**CONTRACT NO: FACD08 RESTROOMS AT PREBLE TRUCK PARKING  
PROJECT: DOT-250005**

**ADDENDUM NUMBER FIVE (5)**

**March 18, 2026**

FACD08 Restrooms at Preble Truck Parking  
Ohio Department of Transportation (ODOT)  
I-70 WB @ MM 01, New Paris, Ohio 45347  
Preble County

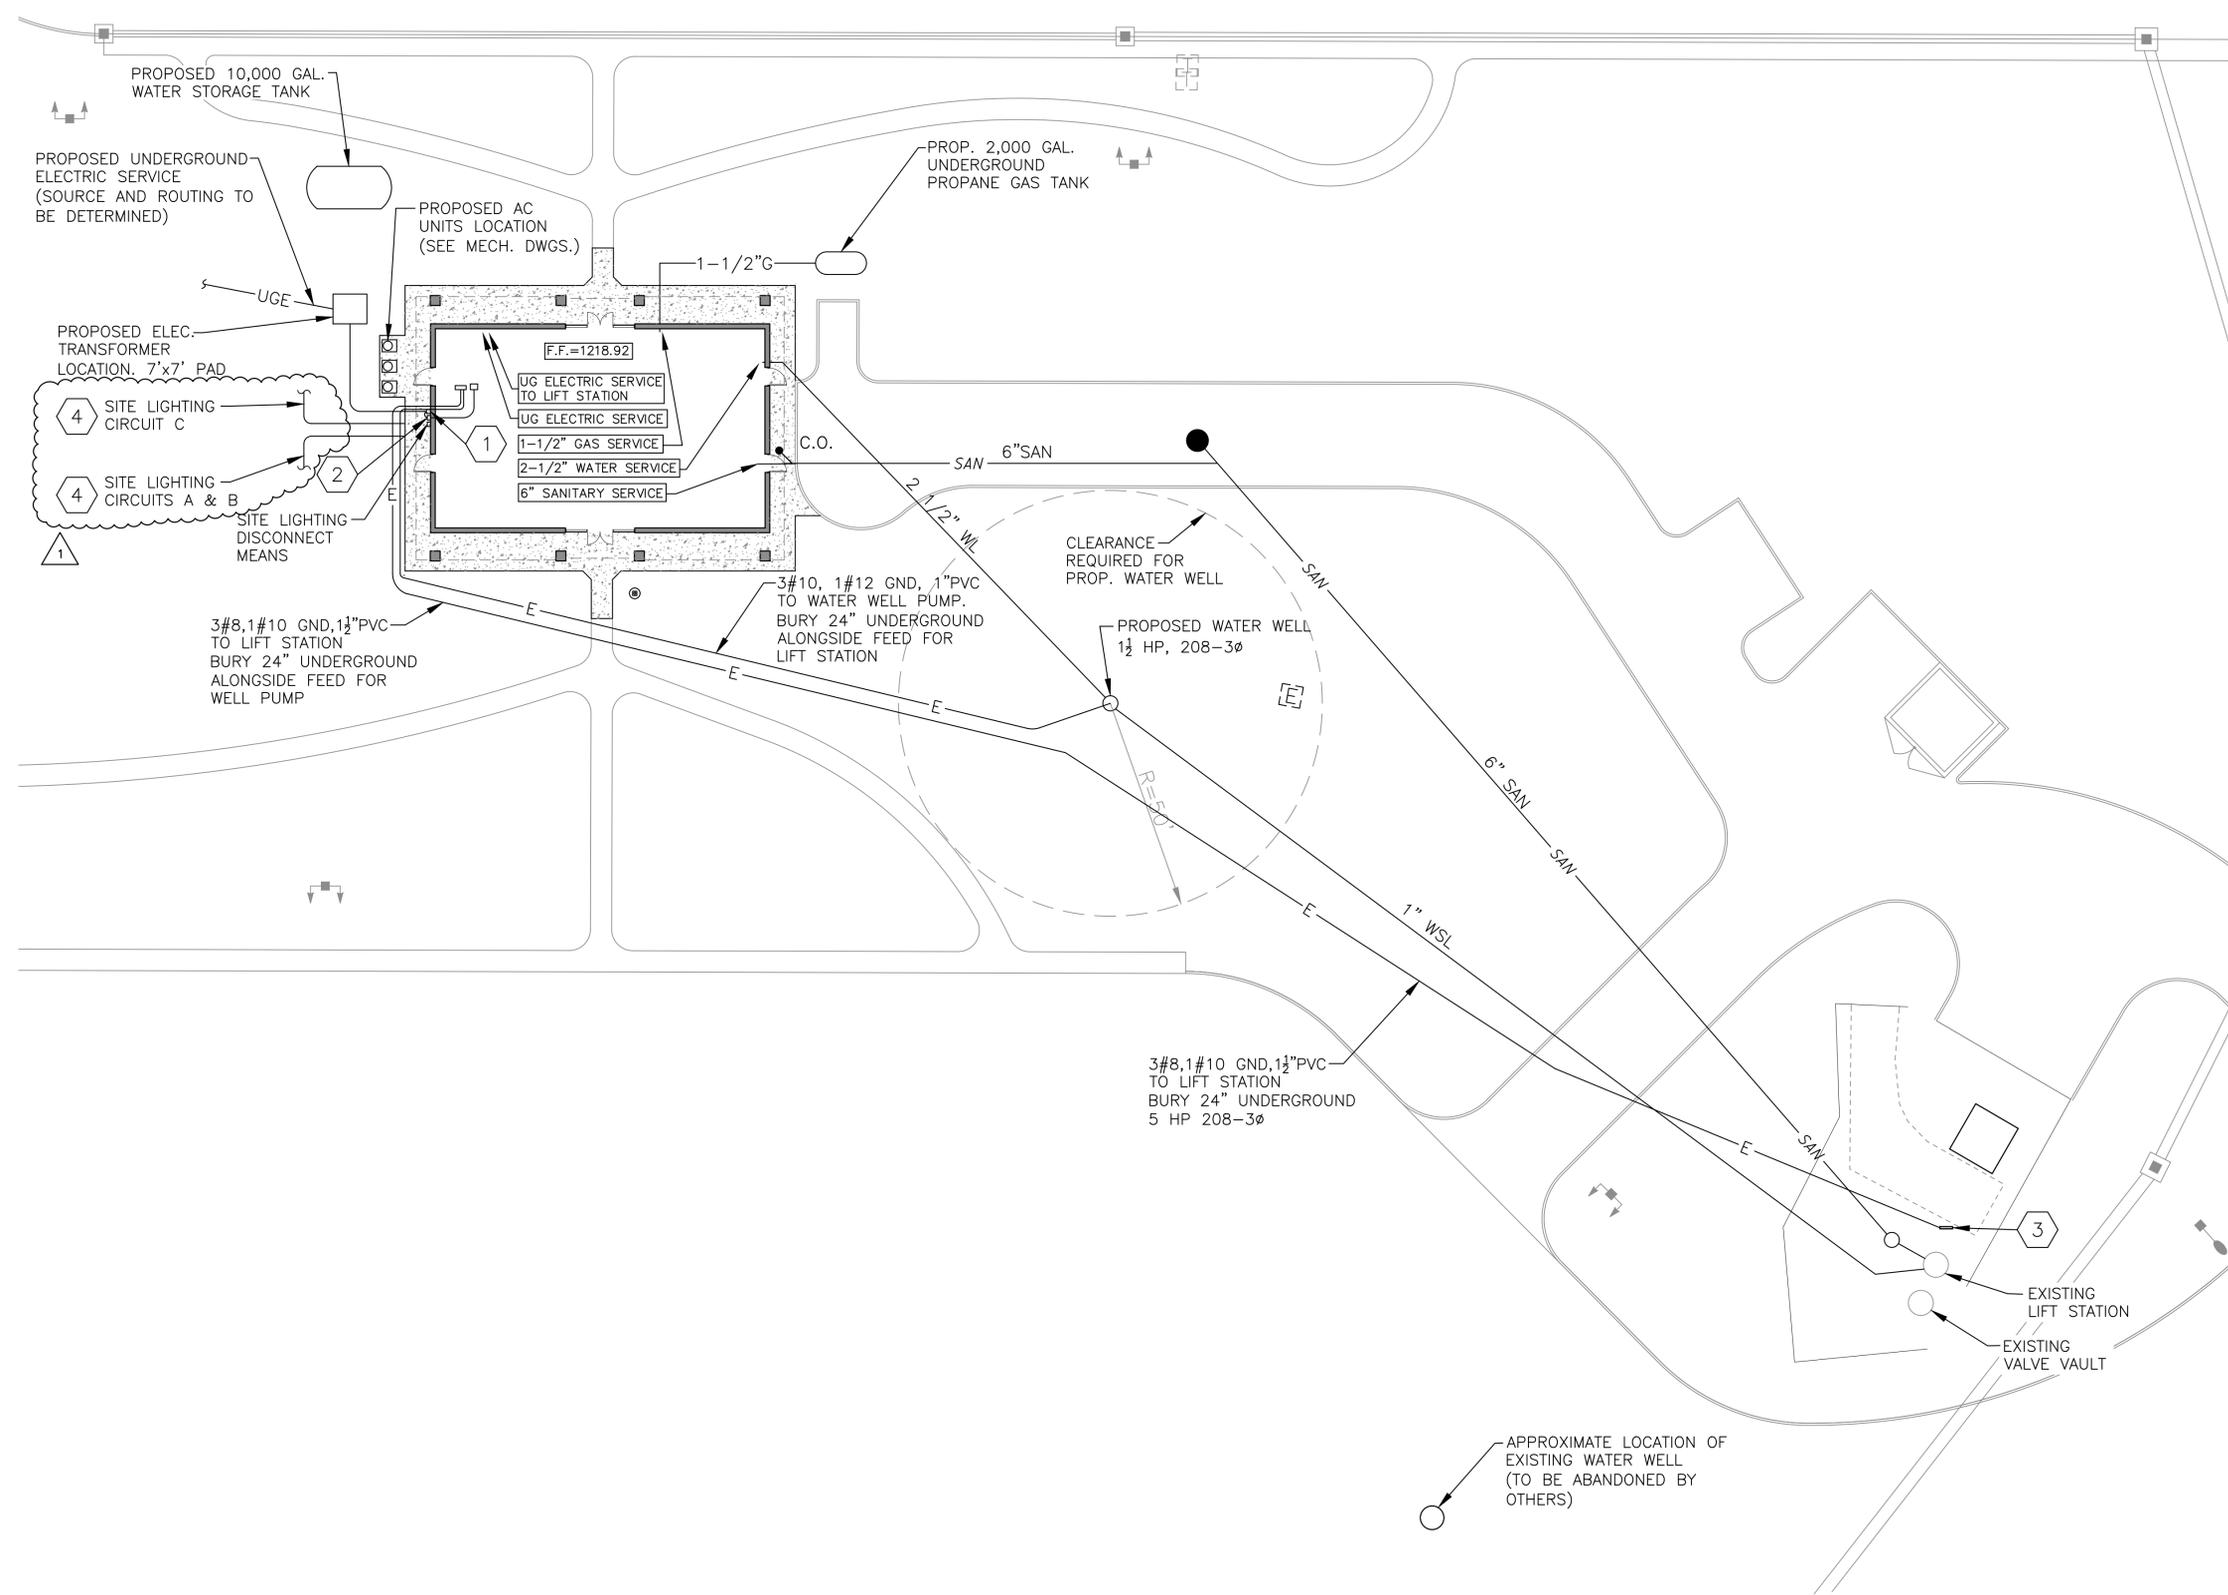
**RFI-2:** Please clarify Addendum 3. No additional information was given. Are we to provide this conduit and power? Just provide the conduit? Are we to provide the power transformer? I assume our only scope is what is highlighted?

**Response:** In Addendum 3, the electrical work shown is part of Structurepoint design for electrical utility provision for site lighting (This is not part of Restroom scope of work). This work is no longer applicable because the Star electrical design provides a revised provision for site lighting electrical feed as part of Addendum 5.

The electrical utility feed highlighted will not go to the small transformer shown near the west exterior of the restroom building, but will go to the 100kva pad mount transformer outside the northwest corner of the restroom building that is part of the Star electrical design. The small transformer is eliminated by Star's revised electrical design under Addendum 5.

Per Addendum 5, the base bid contractor would only provide a conduit under the slab from the site lighting disconnect switch to the site lighting contactor in the mechanical room, a second conduit from the site lighting contactor to an exterior photocell, and a conduit from Panel S to a pullbox outside the restroom West wall. The site lighting contractor would follow the Structurepoint site lighting design to run site lighting circuits A,B,C (conduit and wire) from that pullbox.

AES is expected to supply the wire (buried underground) for the utility feed and the 100kva transformer
